# UNITED STATES PATENT AND TRADEMARK OFFICE

APPLICATION NO.	FILING DATE	FIRST NAMED INVENTOR	ATTORNEY DOCKET NO.	CONFIRMATION NO.
10/568,056	07/13/2007	Thomas G. Eakin	53015-7004	3694

<b>Office Action Summary</b>	<b>Application No.</b> 10/568,056	<b>Applicant(s)</b> EAKIN, THOMAS G.	
	<b>Examiner</b> ILYA Y. TREYGER	<b>Art Unit</b> 3761

### **DETAILED ACTION**

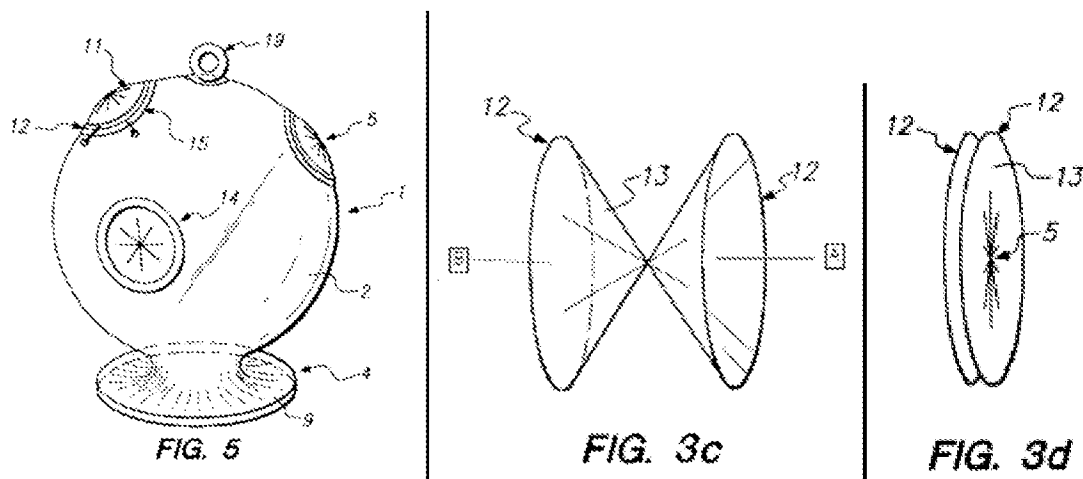
2. Claim 5 rejected under 35 U.S.C. 102(b) as being anticipated by Cuschieri et al. (US 5,480,410).

Cuschieri discloses a fistula isolating bag 2 (Fig. 5) comprising:

first A and second B chambers one of which has an opening 12 (Fig. 3c) for access fully capable to be closable, wherein the chambers are divided by a flexible partition (Fig. 3c), comprising first and second adjacent layers 12 (Fig. 3d), with each layer including an aperture 12 (Fig. 3c), the respective apertures being offset one from the other.

FIG. 2.

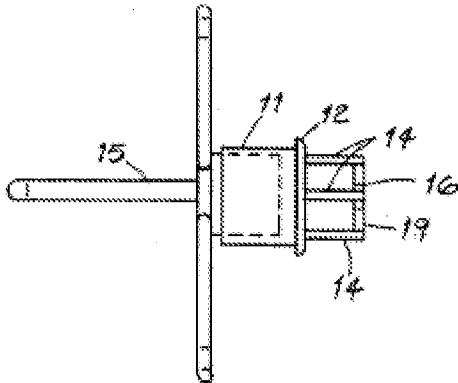
Beevers teaches the use of protective cover 11 for fistula access appliances (Fig. 2).

Since the tracheal opening of Beevers is the fistula solving the same problem as fistula of Cuschieri, it would have been obvious to one having ordinary skill in the art at the time the invention was made to modify the fistula isolating bag of Cuschieri with the protective cover, as taught by Beevers, because such modification would provide the first chamber with isolation from the external air potentially pathogenic content.

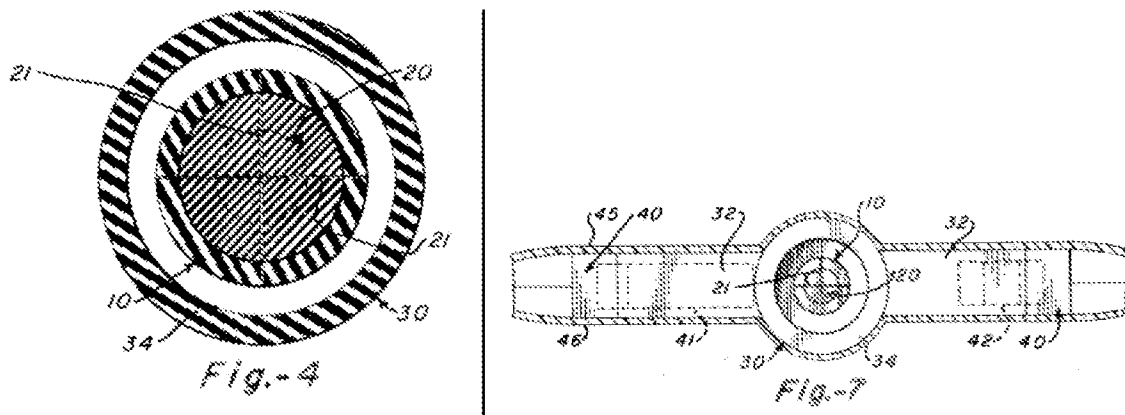
21. In Re claim 6, Cuschieri in view of Beevers disclose the invention discussed above, except for the bag wherein each aperture comprises a respective slit.

Arenberg teaches the use of slit valve in implantable shunts (fistula) (See Figs 4 and 7).

It would have been obvious to one having ordinary skill in the art at the time the invention was made to modify the aperture closure of Cuschieri/ Beevers with the slit valve, as taught by Arenberg, because such modification would convenience the medical treatment access into the first chamber of the bag.

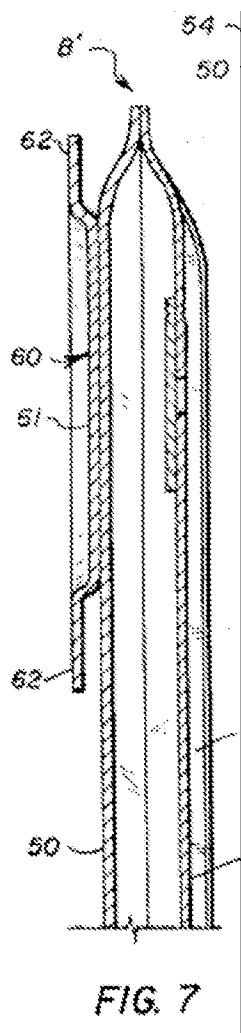
26. In Re claim 20, Cuschieri in view of Beevers disclose the claimed invention discussed above but do not expressly disclose the flexible vessel joint with the fistula appliance.

Brown teaches the stoma bag (flexible vessel) joined to the fistula appliance (Fig. 7).
